Consultation

Isle of Skye – Consultation on the project’s Final Needs Case

Publication date: 12 May 2023

2.8 SHET’s original options scope is presented in figure 2, the updated options scope is in figure 3, and the options descriptions plus FNC scope updates is in table 2.

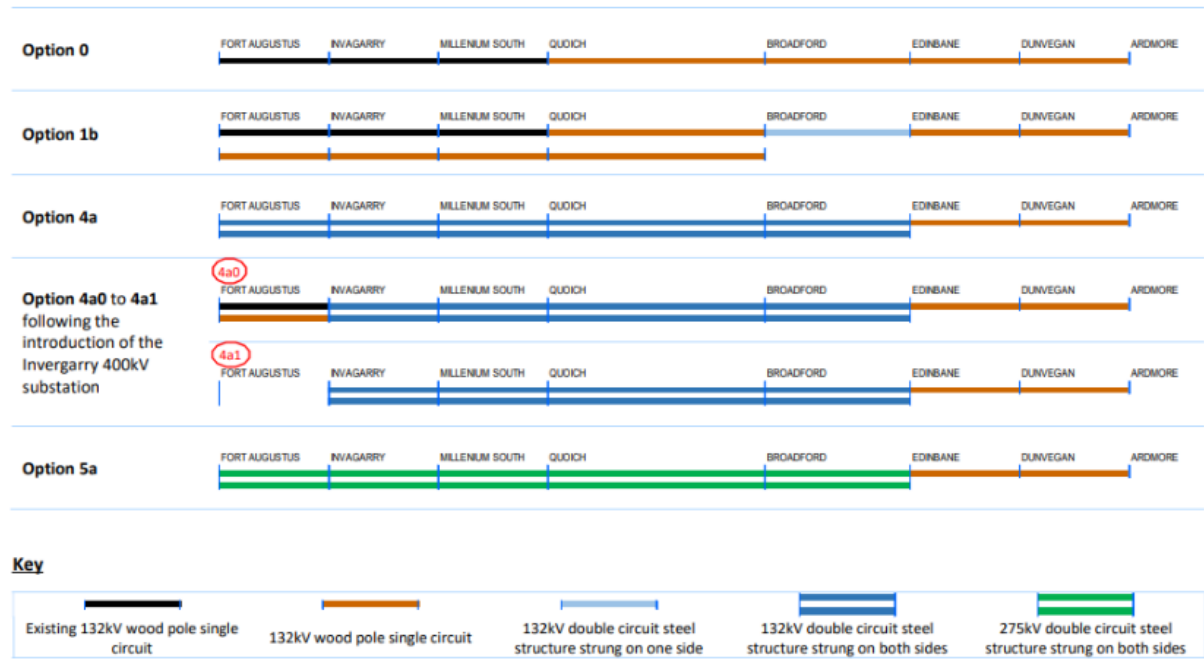
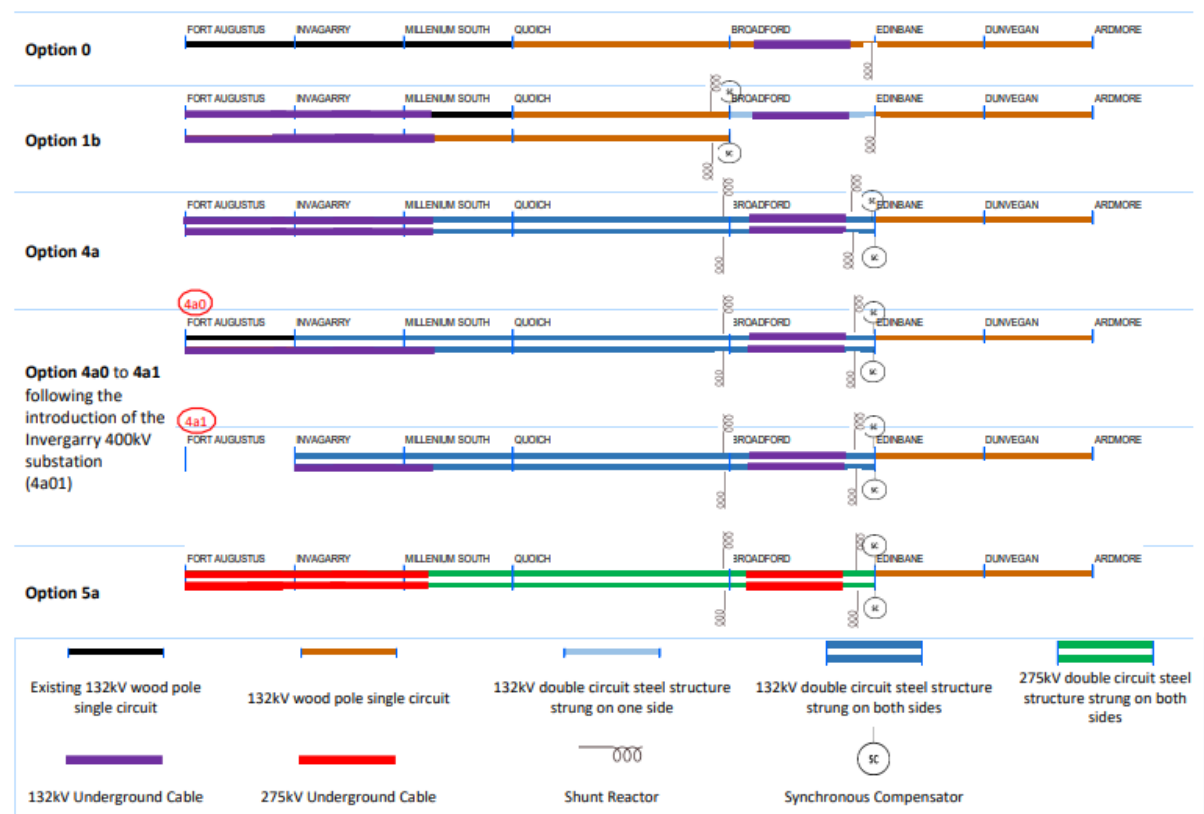
2.7 At the INC stage, SHET flagged that underground cabling may be required to mitigate visual impacts and help secure planning consent. Ongoing stakeholder engagement has confirmed that this will be required. The first section is 9km from Fort Augustus to Quoich, and the second section is 15km within Cuillin Hills National Scenic area. These works triggered project component updates.

2.9 SHET notes that following further development work on option 4a01, the original proposed location of the 400kV substation near Invergarry to accommodate Coire Glas pumped storage scheme is now proposed at a new location approximately 2km away. Given this, the system design would now result in a non-compliant solution in respect of the loss of infeed criteria specified in section 2.6 of the National Electricity Transmission System (NETS) Security and Quality of Supply Standard (SQSS)¹⁷. Considering this, SHET states option 4a01 is no longer viable.

- 2.21 Options 4a and 4a01 are both similar in design and can provide the same power transfer capability, albeit with option 4a01 being costlier. SHET updated their position since the INC on option 4a01 stating that it is no longer viable given its non-compliance with SQSS. We agree that a non-compliant SQSS design solution should be discounted from consideration. Furthermore, given the similarities between option 4a and 4a01, most of the solution is still available via option 4a and at a more competitive investment cost.

- 2.22 SHET flagged at the INC stage that underground cabling may be required to mitigate the landscape and visual impacts of the project and aid the grant of planning consent. Following ongoing stakeholder engagement with statutory consultees, landowners, and others, SHET has confirmed that 24km of underground cabling will be required. We agree that the proposed underground cabling is needed to address the visual amenity impact of the project given that part of the OHL passes through a national scenic area. We also accept that the need to mitigate the impact of the project on visual amenity grounds will be a relevant consideration in the grant of planning permission.
